Service Letter No. 74

SUBJECT: Attach bolts for spring gear and tri-gear models

AIRPLANES AFFECTED: MXT-7-180, S/N 14000C-14137C, M-8-235, S/N 15001C-15005C, MXT-7-160, S/N 17001C-17008C, MT-7-235, S/N 18001C-18109C, MXT-7-180A, S/N 21001C-21097C, M-7-235C, S/N 25001C-25117C, MT-7-260, S/N 27001C-27015C, MX-7-180C, S/N 28001C-28028C, M-7-420AC, S/N 29001C-29007C, M-7-260C, S/N 30001C-30060C, MX-7-180AC, S/N 33001C-33010C, MX-7-160C, S/N 34001C, MT-7-420 S/ N 51001C, 51002C

Detail -1

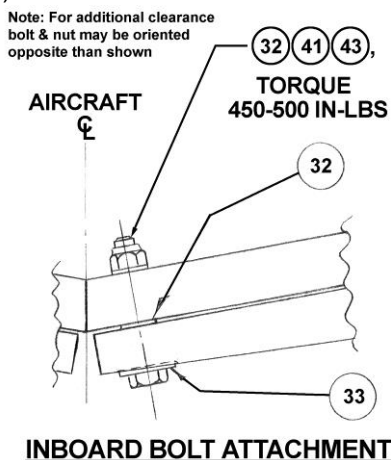
1) Install the following per **Detail -1:**

| (32) | 2 ea. | MS20002-7 | Washer - Flat |
| (41) | 2 ea. | NAS6607-30 | Bolt, High Strength |
| (43) | 2 ea. | 42FLW720 | Nut, High Strength |
| (33) | 2 ea. | 4115B-1 | Washer/Bearing(existing) |

Note: Apply LPS 3 (Rust inhibitor, Heavy Duty) liberally during assembly of inboard bolt attachment – to bolt holes and washer surfaces – to bolts, nuts and washers – also applies to outboard attachment and axle assembly attachment.

Detail -2

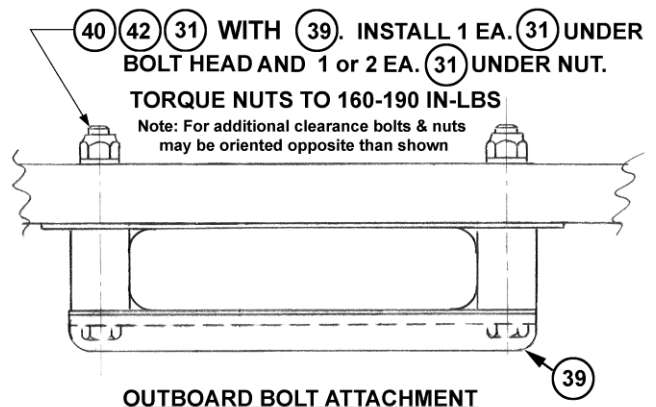
2) Install the following per **Detail -2:**

| (39) | 2 ea. | 4139B-1 | Main L.G. Attach Strap, Upgross |
| (40) | 4 ea. | NAS6606-46 | Bolt, High Strength |
| (40) | 4 ea. | NAS6606-44 | Bolt, High Strength (non Upgross Gear only) |
| (42) | 4 ea. | 42FLW624 | Nut, High Strength |
| (31) | 8 ea. | MS20002-6 | Washer |

Note: The maximum combined height of washers that should be used is 1/8 inch and should have at least one thread of the bolt protruding through the nut.
